DAVIS-BESSE, UNIT 1 XVI Amendment No. 28, 125,170

. Docket Number 50-346 . License Number NPF-3 Serial Number 2197 Attachment Page 9

2.0 SAFETY LIMITS AND LIMITING SAFETY SYSTEM SETTINGS

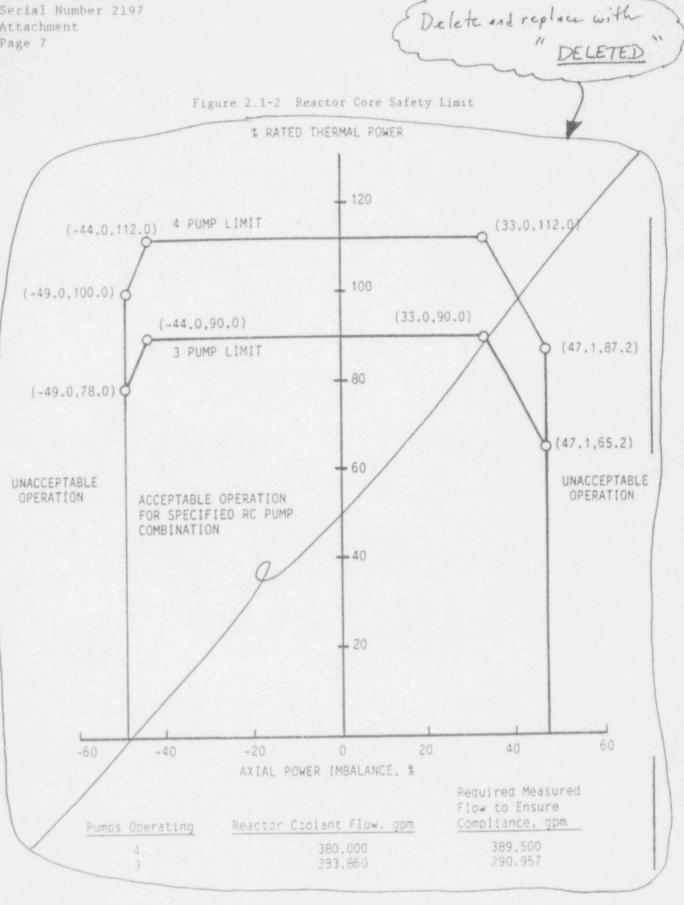
2.1.2 The combination of reactor THERMAL POVER and AXIAL POVER IMBALANCE shall not exceed the passay limit shown in Plaure 2.1.2 for the various combinations of two three and four reactor coolant pump operation.

the CORE OPERATING LIMITS

REPORT

Table 2.2-1. (Cont'd)

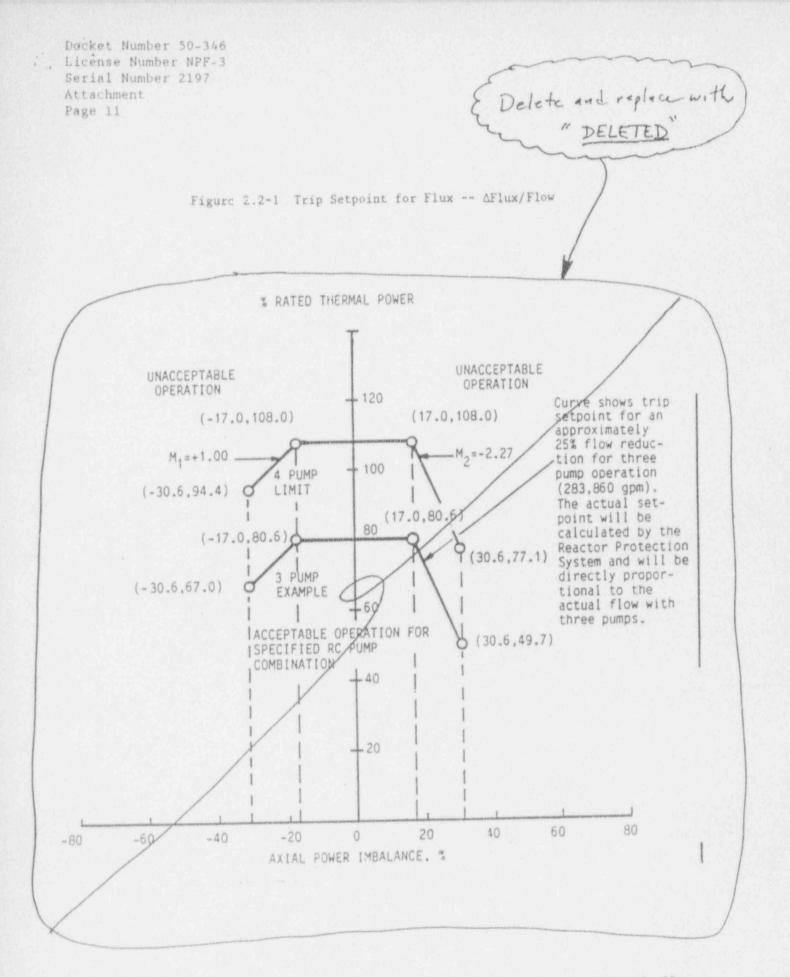
8.	High flux oumber of RC pumps on	<pre><55.1% of RATED THERMAL POWER with one pump operating in each loop</pre>	<pre><55.1% of RATED THERMAL POWER with one pump operating in each loop#</pre>
		<0.0% of RATED THERHAL POWER with two pumps operating in one loop and no pumps operating in the other loop	<0.0% of RATED THERMAL POWER with two pumps operating in one loop and no pumps operating in the other loop!
		<0.01 of RATED THERMAL POVER with no pumps operating or only one pump operating	<pre><0.0% of RATED THERMAL POWER with no pumps operating or only one pump op- erating?</pre>
9,	Containment pressure high	<4 psig	<4 psig≇
		Pump trip setpoints not to exceed the limit lines shown in the CORE OPERATING LIMITS REPORT for four and three pump operation.	Pump allowable values not to exceed the limit lines shown in the CORE OPERATING LIMITS REPORT for four and three pump operation
